Access Compliance Report

Public Rights-of-Way

Intersection ID: 5904	Main Street: COULWOOD_DR	Cross Street: MELLWOOD_DR	Location:	W
ADA ID: 9AAF7B3BEB4A	Ramp Type: Directional1	Initial Pass/Fail: Pass	Overall Compliance: No	Severity Score: 7.5

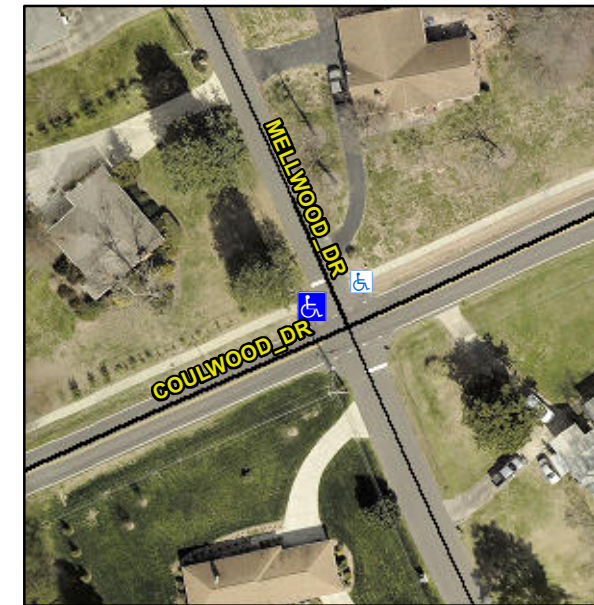
R304.2.2-Perp, R304.3.2-Para,
R304.5.3, R305.1.4, R305.2, R304.5.4

Compliance	Description	Data	Compliance	Description	Data
N/A	Ramp Length (in)	54.5	Yes	Grade Break?	Yes
Yes	Ramp Width (in)	60.0	Yes	Grade Break Slope (%)	2.7
Yes	Ramp Slope (%)	5.2	No	Grade Break XSlope (%)	2.9
Yes	Ramp XSlope (%)	1.5			
N/A	Flare Type LT	N/A	N/A	Flare Type RT	N/A
N/A	Flare Slope LT (%)	N/A	N/A	Flare Slope RT (%)	N/A
N/A	Flare Traversable LT?	N/A	N/A	Flare Traversable RT?	N/A
Yes	Landing Length (in)	60.5	Yes	DWS Provided?	Yes
Yes	Landing Width (in)	60.0	Yes	DWS Contrast?	Yes
No	Landing Slope (%)	7.0	Yes	DWS Length (in)	24.0
Yes	Landing X Slope (%)	0.2	No	DWS Full Width?	No
N/A	Landing Curb? (Y/N)	N/A	No	DWS Offset LT (in)	6.5
N/A	Shared Landing?	No	Yes	DWS Offset RT (in)	24.5
Yes	Gutter Ponding?	No	No	Gutter Slope (%)	5.3
Yes	Gutter Lip Ht (in)	0.0	No	Gutter X Slope (%)	4.5
N/A	Painted X Walk1?	No		Road Slope (%)	3.9
	X Walk 1 Direction	To NE		Road X Slope (%)	2.8
	X Walk 1 Width (in)	N/A		Clear Space?	Yes

Remove & Replace Entire Ramp.
Remove & Replace Gutter.
